**PROPOSED ST. PAUL ANTIOCHIAN ORTHODOX CHURCH**  
**MAJOR PLAN 2023-104**  
**ATTACHMENTS**

**TO: PLANNING COMMISSION**  
**FROM: GREGG ADAMS, PLANNER**  
**SUBJECT: PROPOSED ST. PAUL ANTIOCHIAN ORTHODOX CHURCH**  
**MAJOR PLAN 2023-104**  
**REQUEST FOR SKETCH PLAN REVIEW**  
**DATE: SEPTEMBER 15, 2023**  
**COPIES: BOARD OF COMMISSIONERS, T. PETRUCCI, D. MANHARDT,**  
**L. HARRIER, J. ZATOR, ESQ., J. ALDERFER, ESQ, A.**  
**TALLARIDA, S. PIDCOCK, APPLICANT, SUB. FILE 2023-104**

SUBJECT: South Whitehall Township  
Proposed St. Paul Antiochian Orthodox Church  
Major Plan #2023-104  
Sketch Plan Review

South Whitehall Township  
Proposed St. Paul Antiochian Orthodox Church  
Major Plan #2023-104  
Sketch Plan Review

**SKETCH PLAN**  
**PROPOSED ST. PAUL ANTIOCHIAN ORTHODOX CHURCH**  
670 S. CEDAR CREST BLVD.  
SOUTH-WHITEHALL TOWNSHIP  
LEHIGH COUNTY, PENNSYLVANIA

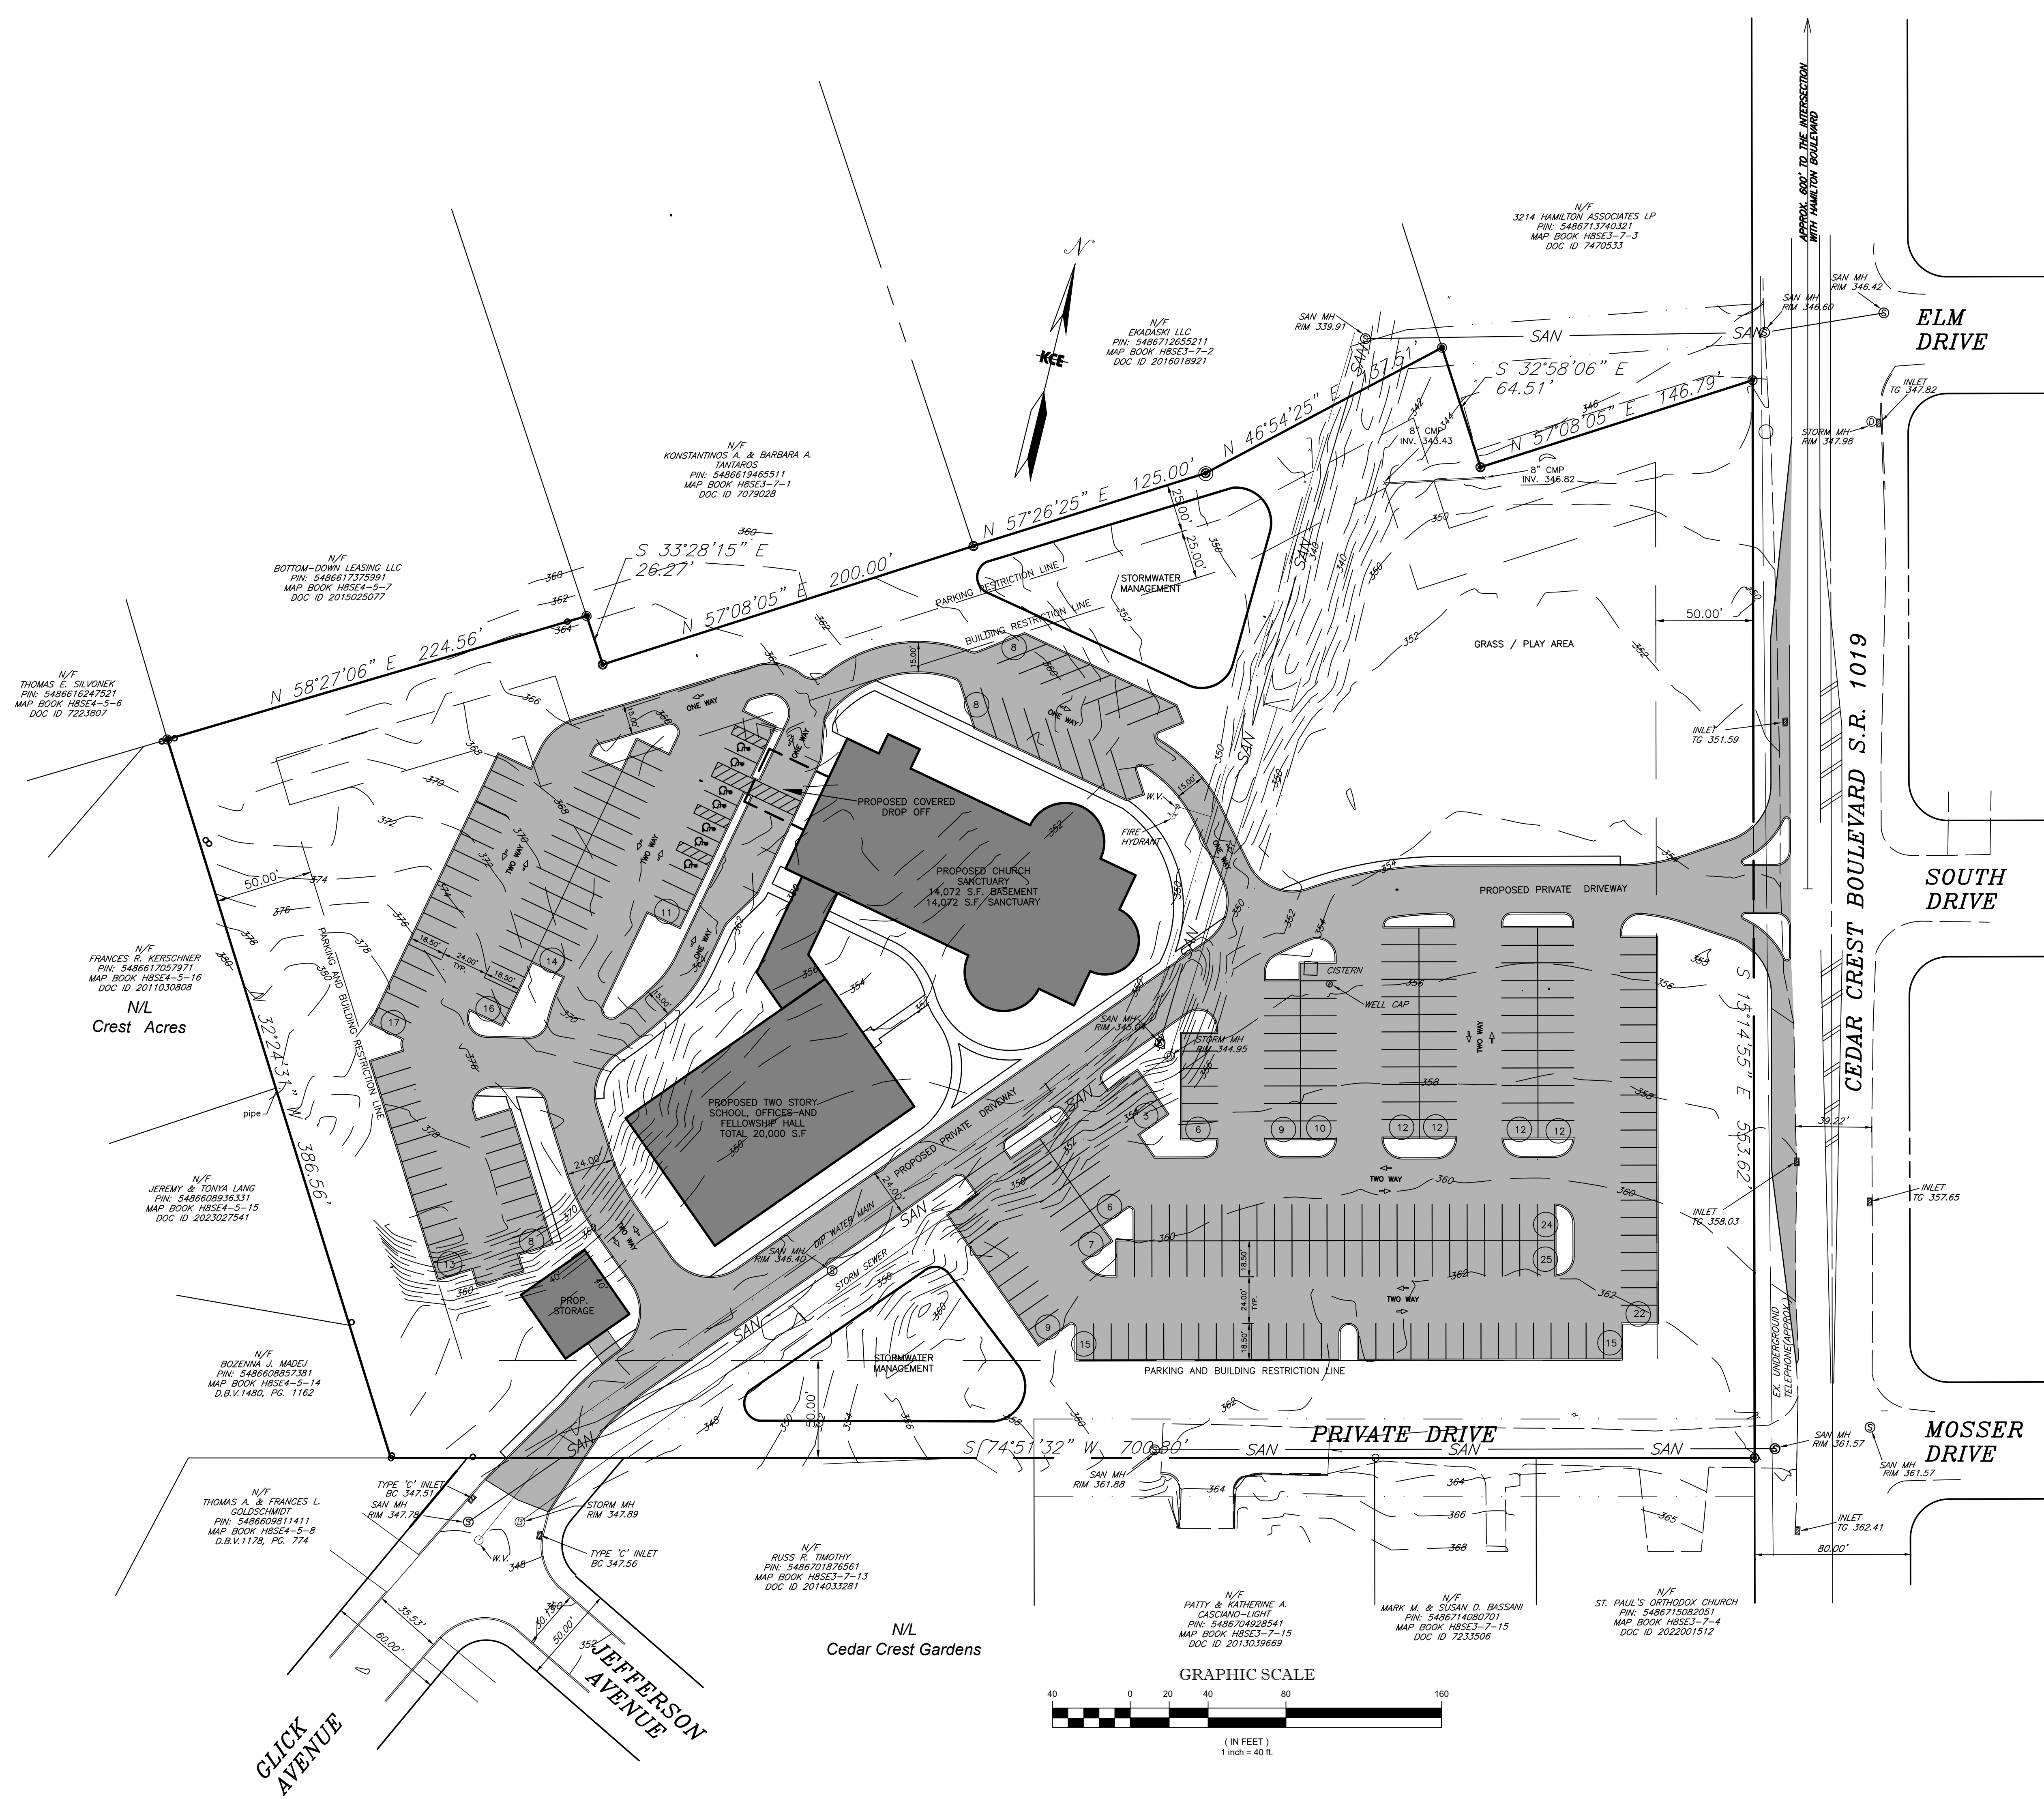
1. As proposed, the private driveway for this site would appear to function as a thoroughfare between Cedar Crest Boulevard and the existing residential area southwest of the site (Glick Avenue). A revision to this arrangement should be considered. We note the following for further discussion with the Township:

- a. The connection of Glick Avenue be revised to reflect a cul-de-sac termination of Glick Avenue with a standard driveway connection for the site;
  - b. The connection to Glick Avenue or Cedar Crest Boulevard be removed; and

- c. The driveway be revised to be a public road extension from Glick Avenue to Cedar Crest Boulevard.
2. The vehicular circulation design has not been reviewed for this private facility and is the responsibility of the Developer. Depending on the final condition of the proposed driveway, the number of access aisles to the parking facility to the south of the proposed driveway should be reduced. We note that the parking facility access aisles should meet the requirements for Cedar Crest Boulevard, SALDO §312-36(c)(4)(B);

3. An off-site regional drainage area is tributary to the existing large diameter storm sewer pipe system through the site. The stormwater management system plans and design calculations should consider this drainage area and its overland flow component to be managed through the development to show there will be no impacts to the downstream properties. Any proposed storm sewer connections to this existing storm sewer system should consider the nature of the flow in the pipe;

4. The project is located in the Little Lehigh Creek Watershed Act 167 Subareas 194 and 196 which is a 30/100 percent release rate district. Stormwater management system plans and design calculations which demonstrate that the proposed development will meet the Act 167 runoff requirements and the water quality volume (WQv) requirements for discharge to any contiguous properties for each discharge point should be submitted for review with the Preliminary Plan;

5. The following improvements along the property frontage are required along Cedar Crest Boulevard per the SALDO: right-of-way dedication, cartway widening, curb, sidewalk, monuments, shade trees, etc. (SALDO §312-26(a) §312-35(b), §312-36, and §312-40 pertain), and should be shown on the Plans. We note that the improvements along Cedar Crest Boulevard and the proposed intersection to the site are to be reviewed and permitted by PennDOT;

7. Identify required and available sight distances for the proposed driveway;
8. Provide truck turning templates (trash, fire, and delivery) for the site as part of the Preliminary Plan submission to demonstrate the driveway radii are adequate to handle trucks entering and exiting the site without impeding oncoming traffic. In addition, truck turning templates should be provided demonstrating the ability of trucks to maneuver through the site (trash trucks to/from trash dumpster, fire truck around building, and delivery vehicles to designated loading zone or delivery area);

10. Address the following Sketch Plan related comments:
  - a. Provide a signed statement that the applicant is the owner, or authorized by the owner to make an application for the land should be provided on the Plan, SALDO §312-10(b)(4);

- b. List the acreage of the tract, SALDO §312-10(b)(5)(A);
  - c. Provide the linear feet of the proposed driveway, SALDO §312-10(b)(5)(C);
  - d. Provide existing and proposed impervious coverage, SALDO §312-10(b)(5)(H);

- e. Label the right-of-way width along Cedar Crest Boulevard, SALDO §312-10(b)(9); and
  - f. Show any existing buildings and vegetation (e.g., trees), SALDO §312-10(b)(12).
